Access Compliance Report

Public Rights-of-Way

Intersection ID: 20513	Main Street: ALTACREST_PL	Cross Street: W_ARROWWOOD_RD	Location: SE
ADA ID: FA47A1A343BB	Ramp Type: BlendTrans2	Initial Pass/Fail: Pass	Overall Compliance: No
			Severity Score: 10.25

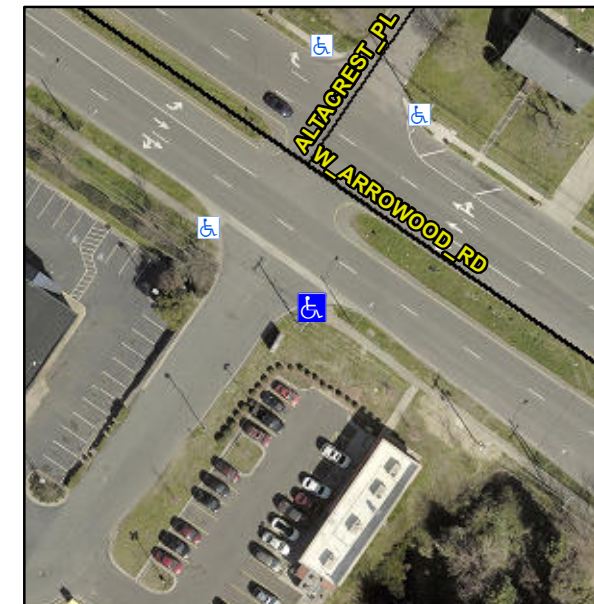
R304.5.3, R305

Compliance	Description	Data	Compliance	Description	Data
N/A	Ramp Length (in)	72.0	Yes	BlendTrans Slope (%)	1.3
Yes	Ramp Width (in)	52.0	No	BlendTrans XSlope (%)	3.3
N/A	Flare Type LT	None	N/A	Flare Type RT	None
N/A	Flare Slope LT (%)	N/A	N/A	Flare Slope RT (%)	N/A
N/A	Flare Traversable LT?	N/A	N/A	Flare Traversable RT?	N/A
N/A	Landing Length (in)	N/A	No	DWS Provided?	No
N/A	Landing Width (in)	N/A	N/A	DWS Contrast?	No
N/A	Landing Slope (%)	N/A	N/A	DWS Length (in)	N/A
N/A	Landing X Slope (%)	N/A	N/A	DWS Full Width?	No
N/A	Landing Curb? (Y/N)	No	N/A	DWS Offset (in)	N/A
N/A	Shared Landing?	No			
Yes	Gutter Ponding?	No	Yes	Gutter Slope (%)	0.5
Yes	Gutter Lip Ht (in)	0.0	No	Gutter X Slope (%)	2.5
N/A	Painted X Walk1?	No	N/A	Painted X Walk2?	No
	X Walk 1 Direction	To NE		X Walk 2 Direction	To NW
	X Walk 1 Width (in)	N/A		X Walk 2 Width (in)	N/A
	X Walk 1 Slope (%)	8.3		X Walk 2 Slope (%)	2.4
	X Walk 1 X Slope (%)	0.2		X Walk 2 X Slope (%)	5.0

Remove & Replace Curb Ramp With Two New Directional Ramps or Equivalent. Remove & Replace Gutter.
